**Comanche Peak Nuclear Power Plant, Units 3 & 4
COL Application**

**Part 3,
Environmental Report
Update Tracking Report**

Revision 1

Figure 1.1-5 Electrical Transmission Corridors

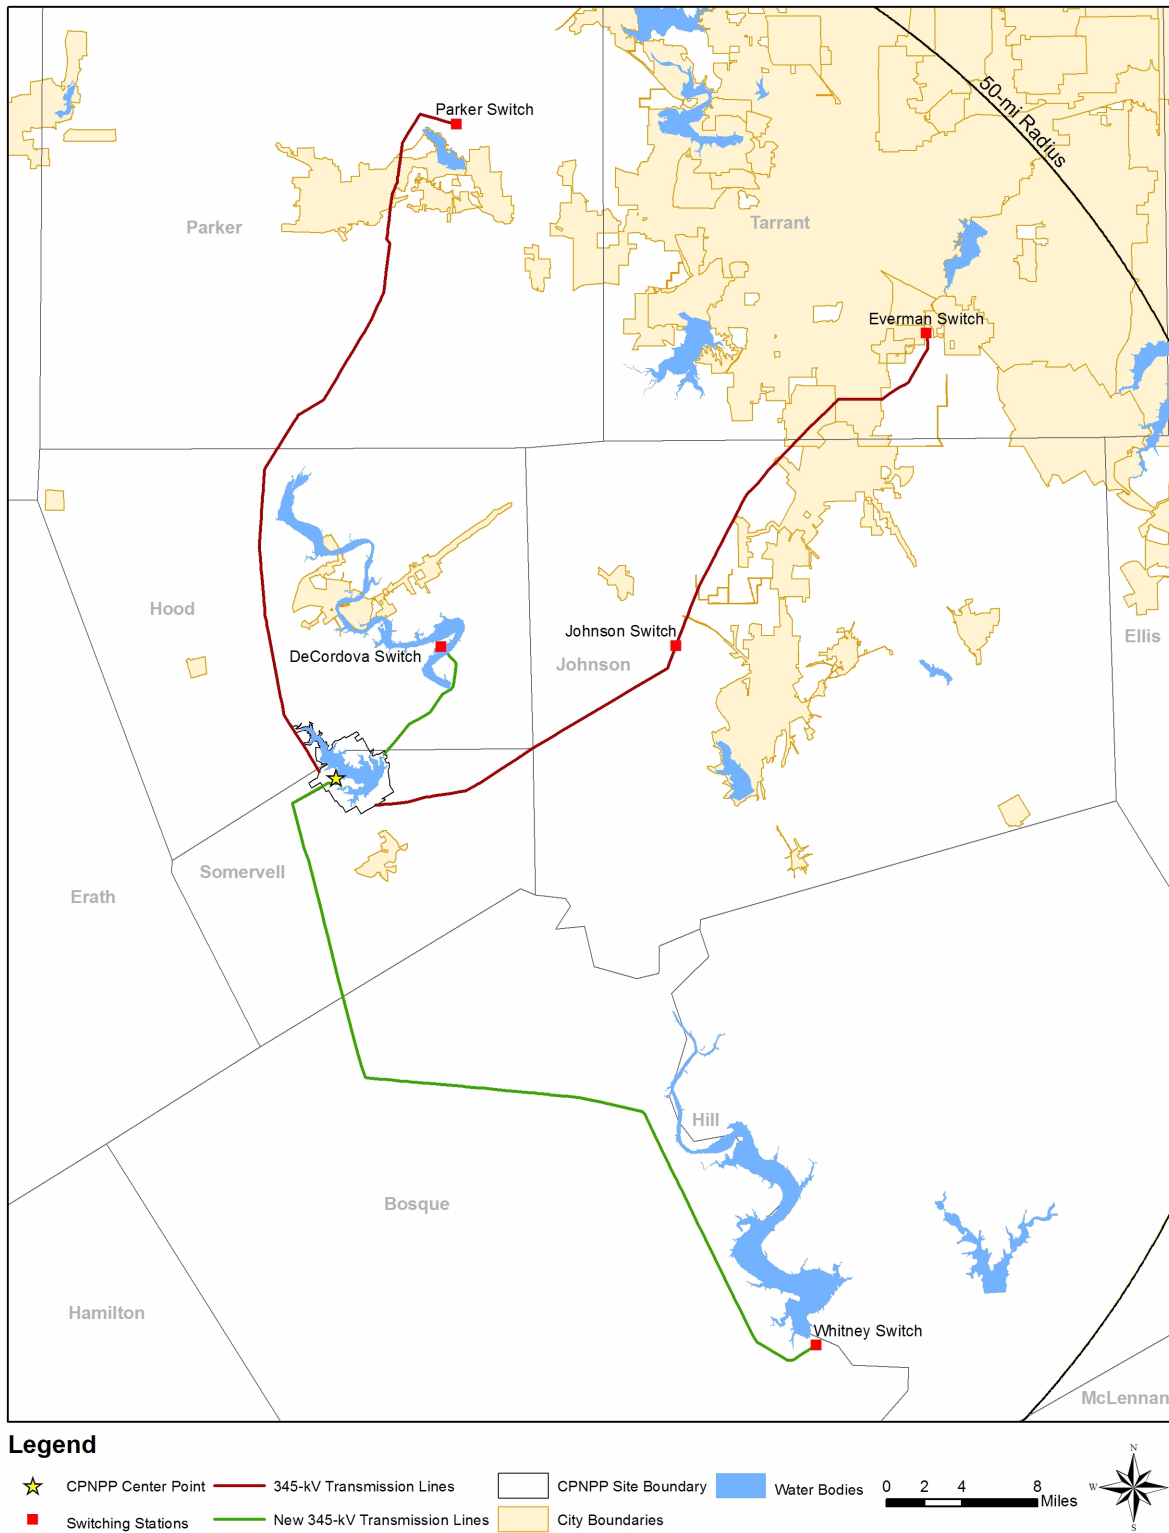
LU-02

Figure 2.2-2 CPNPP Region Federal Lands

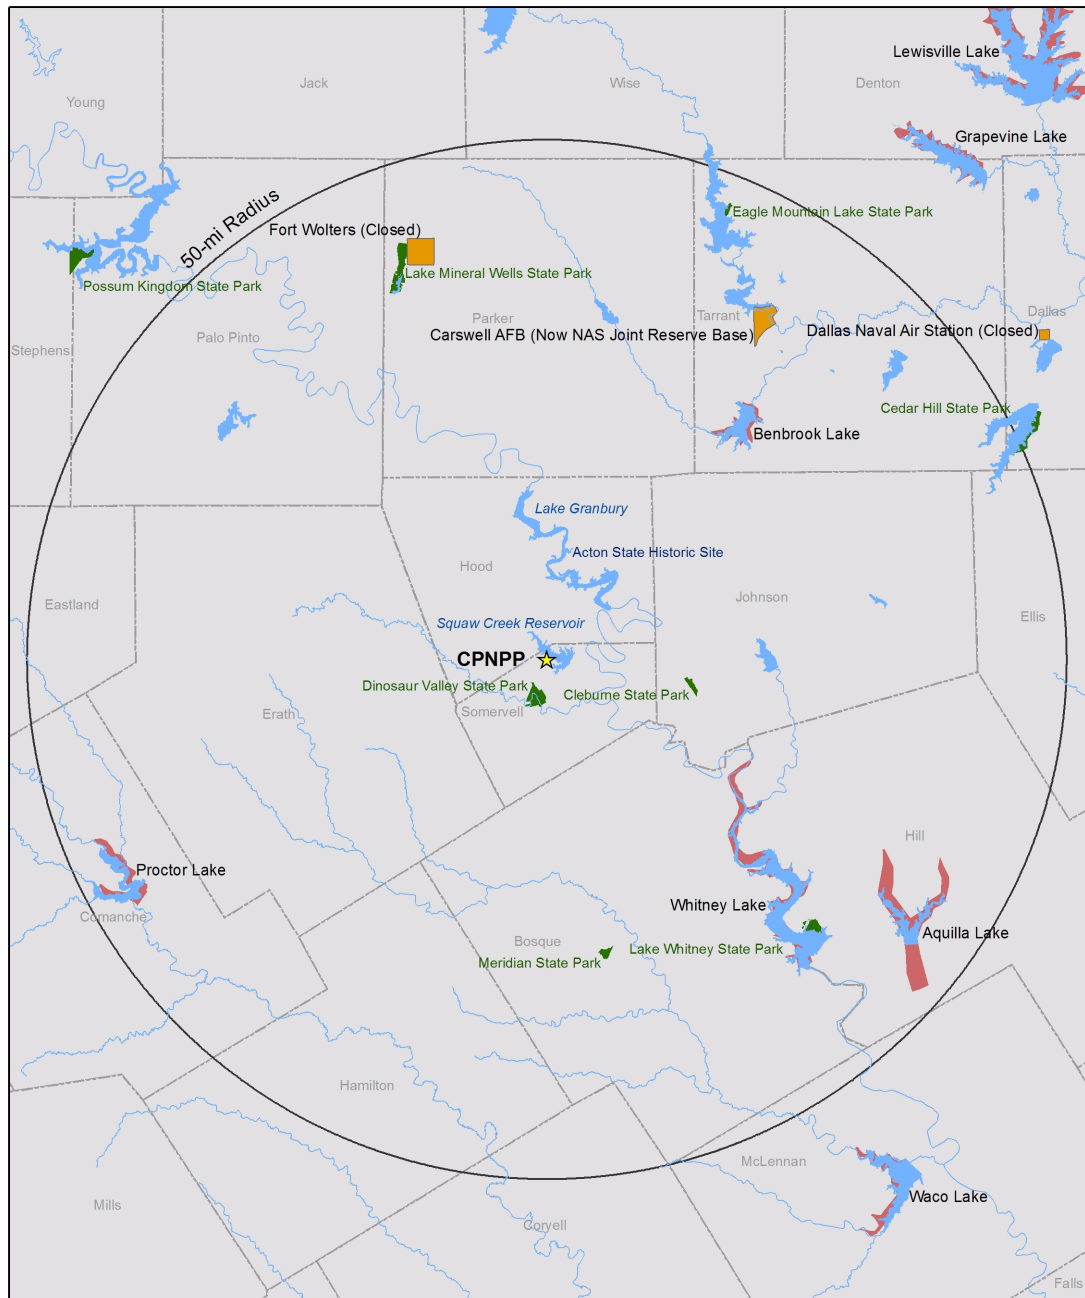
Within the region of CPNPP, there are ~~five~~^{four} separate federal land holdings as shown in Figure 2.2-2 (US Census 2000). ~~Four~~^{Three} of these federal land holdings are lakes developed by the Army Corps of Engineers: (1) Benbrook Lake at ~~5169~~^{5183.9} ac; (2) Aquilla Lake at ~~17,294~~^{17,280} ac; and (3) Lake Whitney at ~~21,841~~^{21,824} ac; and (4) Proctor Lake at 6505 ac. The remaining federal land holding is Naval Air Station (NAS) Fort Worth, Joint Reserve Base at Carswell. Commissioned on October 1, 1994, the base was previously known as Carswell Air Force Base and became NAS Fort Worth, Joint Reserve Base at Carswell. Covering ~~3240~~³²⁶⁴ ac.

LU-08

Figure 9.3-2 Locations of the Candidate Sites

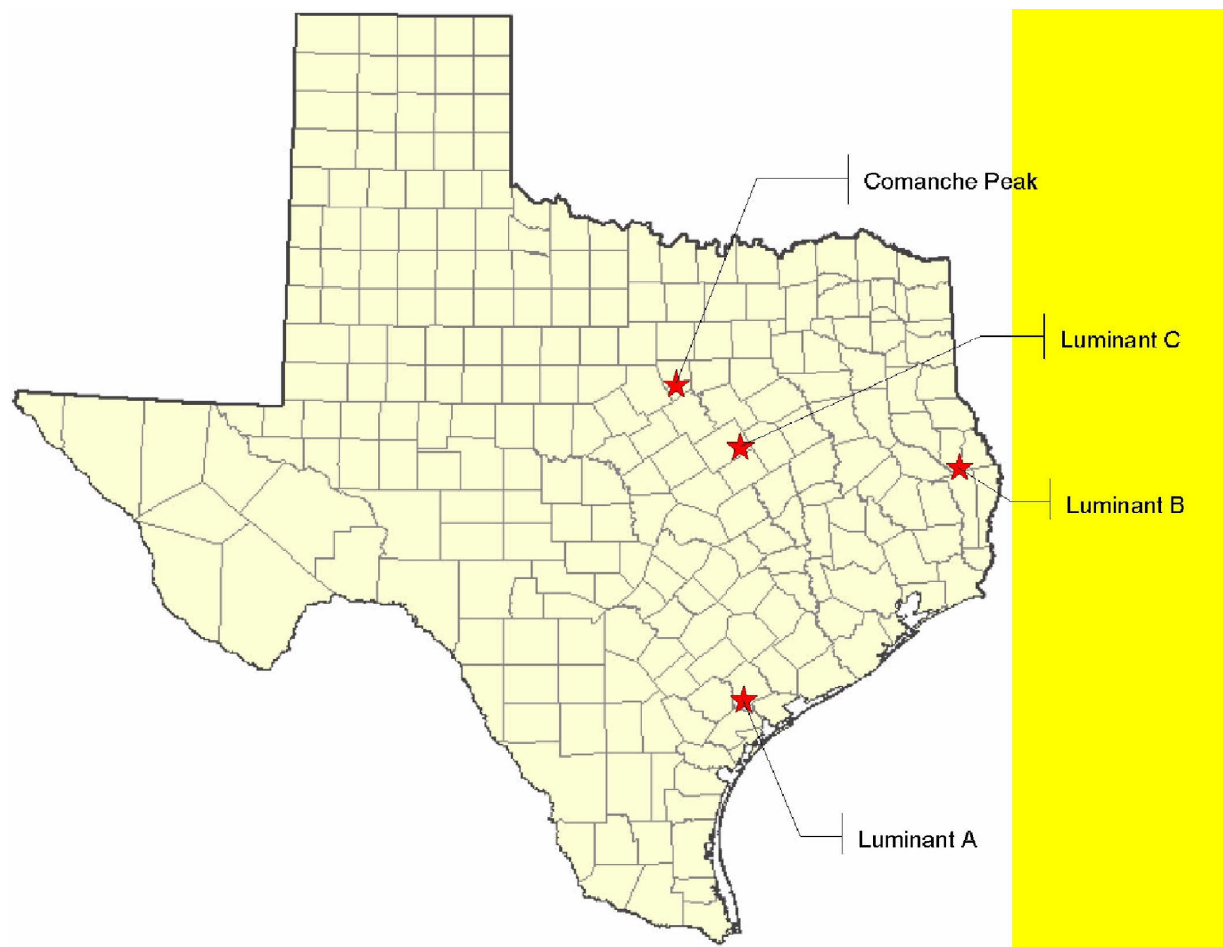
9.3-65 9.3-66, 9.3-67, 9.3-68, 9.3-69, 9.3-70, 9.3-71, 9.3-72, 9.3-73, 9.3-74			
CTS-00690	Figure 9.3-2	-	Editorial Correction	Remove box with “Proprietary Information – Withheld Under 10 CFR 2.399 (a) (4)” and provide figure.	1
ALT-09	9.2	9.2-28	Editorial Correction	Remove the sentence “The levelized cost of electricity produced from pulverized coal fired power plants is \$0.033/kWh - \$0.041/kWh”	1
ALT-09	9.2	9.2-30	Erratum	Replace \$575 with \$544	1

~~Proprietary Information - Withheld Under 10 CFR 2.390 (a)(4)~~
